Addendum #1
Gallup Park Improvements, ITB 4272
City of Ann Arbor, Parks and Recreation Services
Due: Thursday, February 21, 2013 at 10:30 a.m.

EXHIBIT A FOR ADDENDUM #1

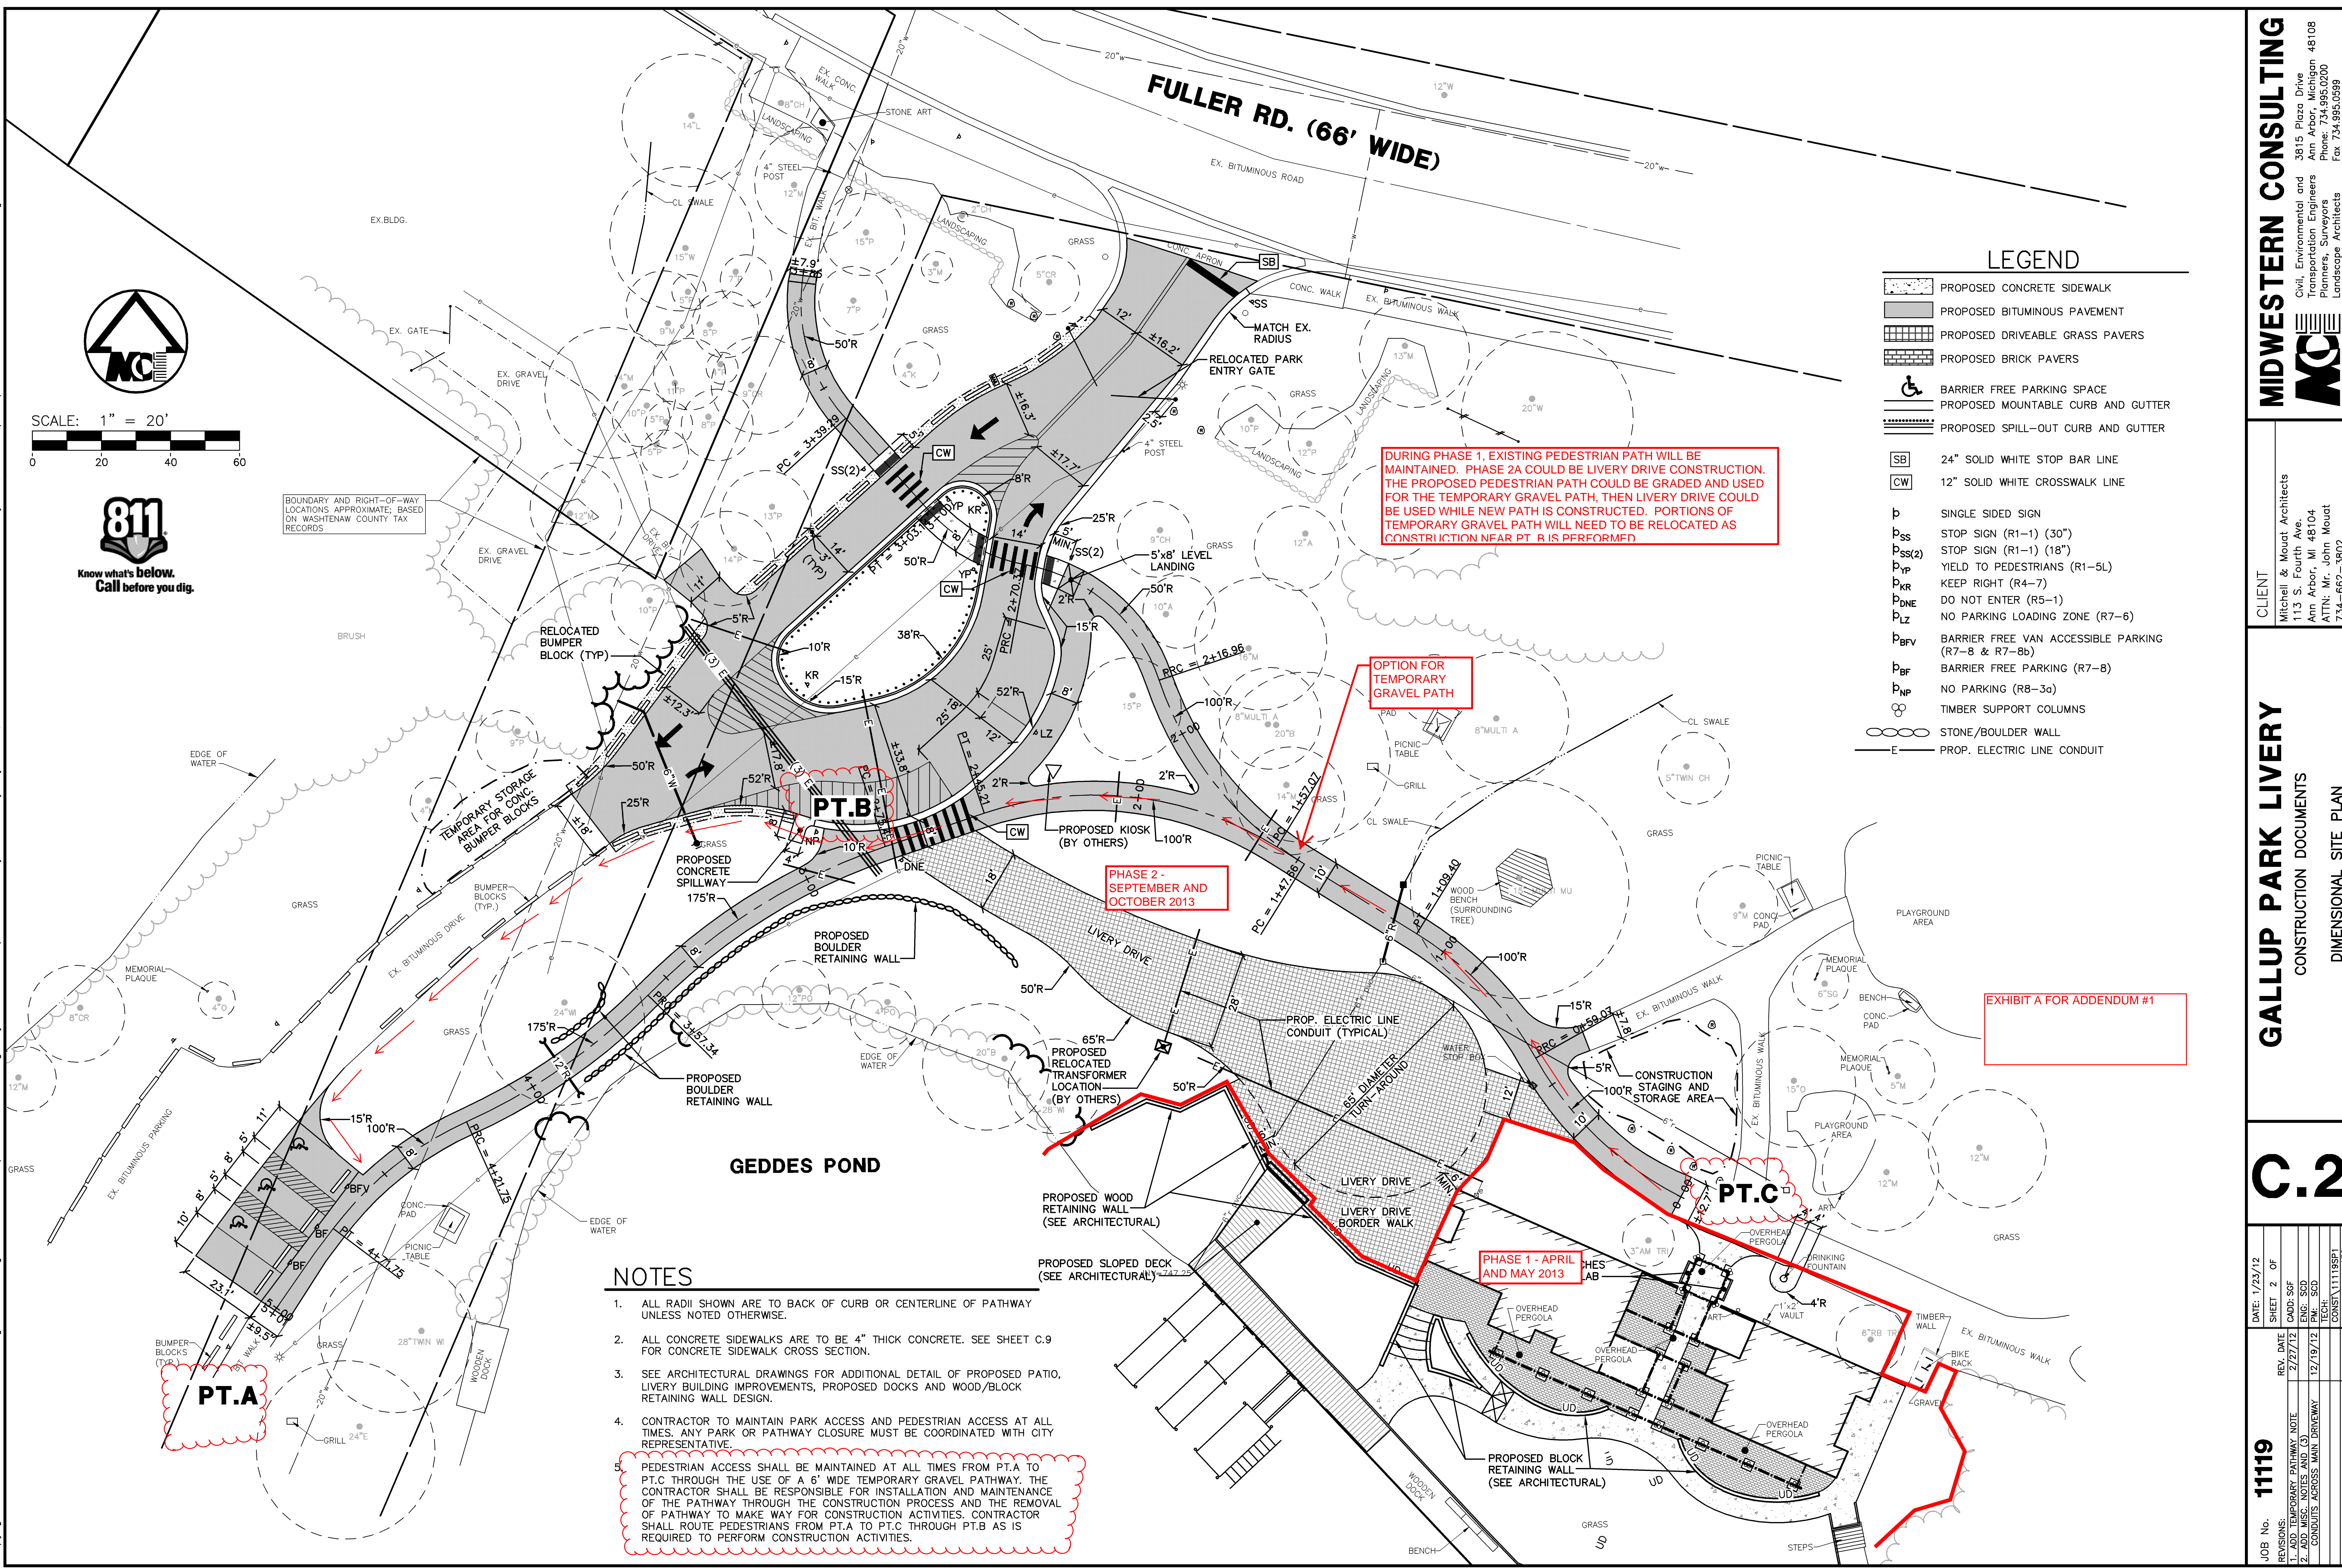
8. Exhibit A, attached, shows conceptual phasing and one option for the location of the temporary gravel path. The City will need to approve the final location of the temporary gravel path.

DURING PHASE 1, EXISTING PEDESTRIAN PATH WILL BE MAINTAINED. PHASE 2A COULD BE LIVERY DRIVE CONSTRUCTION. THE PROPOSED PEDESTRIAN PATH COULD BE GRADED AND USED FOR THE TEMPORARY GRAVEL PATH, THEN LIVERY DRIVE COULD BE USED WHILE NEW PATH IS CONSTRUCTED. PORTIONS OF TEMPORARY GRAVEL PATH WILL NEED TO BE RELOCATED AS CONSTRUCTION NEAR PT. B IS PERFORMED.

OPTION FOR TEMPORARY GRAVEL PATH

16. Sheet C.2: The relocated bumper blocks shall be installed on 8" of 21AA limestone.
